**TOWN OF SHELBURNE**  
**SEWER/WATER RELOCATION (AOT WORK)**  
**PLAN AND PROFILE**  
**STA. 369+00 TO 375+00**

**CIVIL ENGINEERING ASSOCIATES, INC.**  
SHELBURNE, VERMONT

SHEET **C-23**

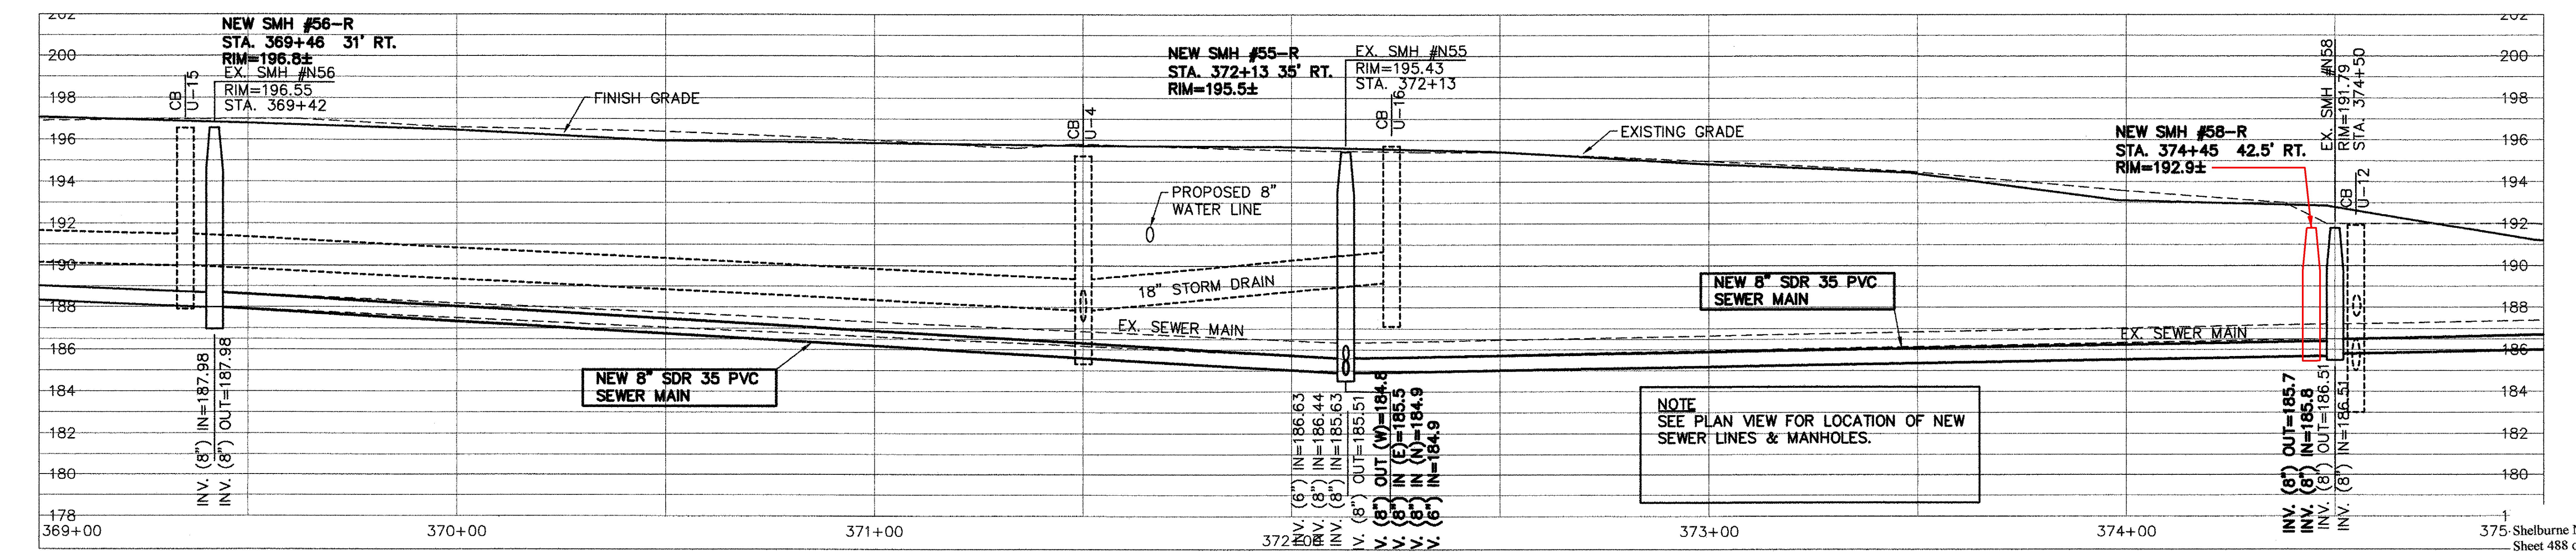
NO.	DATE	DESCRIPTION
1.	11/10/09	FIELD MARK UPS ADDED TO THE PLANS
